2. Item A – Proposed Site Development Plan For Conifer Westminster Way, LLC, (Westminster Way Apartments)
   Item A – Proposed Site Development Plan For Conifer Westminster Way, LLC, (Westminster Way Apartments)

To: Westminster Planning and Zoning Commission

From: Andrew R. Gray, Comprehensive Planner

Subject: Proposed Site Development Plan for Conifer Westminster Way, LLC

SHEET TITLE:
EXTERIOR ELEVATIONS

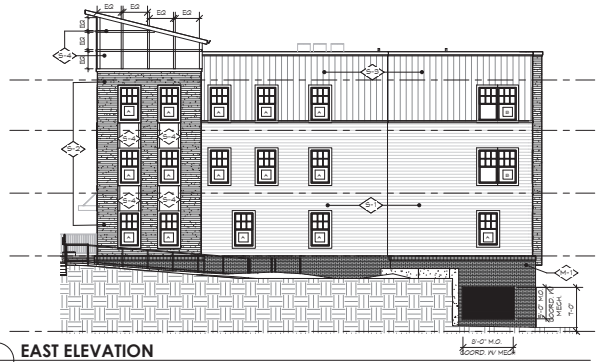
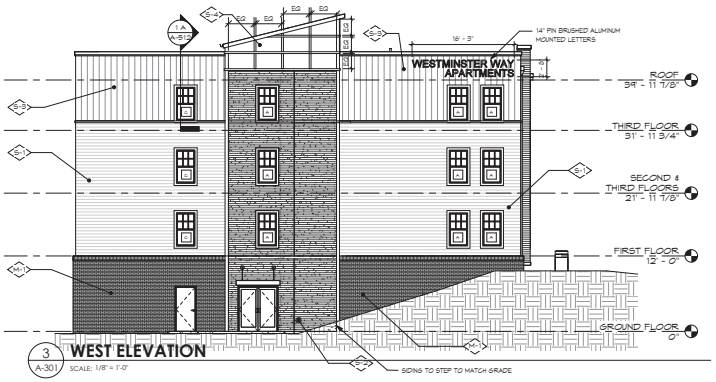
Modification of Adopted Preferences (2016 Development Design Preferences Manual)	
Standard	Staff Comment
Per page #25, Including building elements of various heights within the overall project design is encouraged	Please add varying heights similar to what is provided for on the West Main Street frontage.

Per page #27, Roof-lines should be segmented and varied within an overall horizontal context. Varying heights are encouraged	Please add varying heights similar to what is provided for on the West Main Street frontage.
The City prefers that loading docks, trash collection areas, outdoor storage and similar utility facilities and functions be incorporated into the overall design of the site. These facilities should be shielded from the public eye and kept out of view of adjacent properties and streets.	Please provide screening around the proposed transformer that will not interfere with the underground utilities.

The building has varying context as designed with different materials at the north and south elevations including two colors of concrete siding, one color of vinyl siding run horizontally, one color of siding run vertically, brick as well as paneling at the towers and at the bump outs. If further varied context (siding/façade) is required, please consider a modification request for this

design preference. (Color elevation is attached to this request, and we are providing a view from all sides for Planning Commission if not sooner)

The building has varying heights on all sides with the book end towers on the far east and west sides providing relief to the east and west elevations. However due to the solar panel collector design, we do not believe any further building height modification can be achieved.
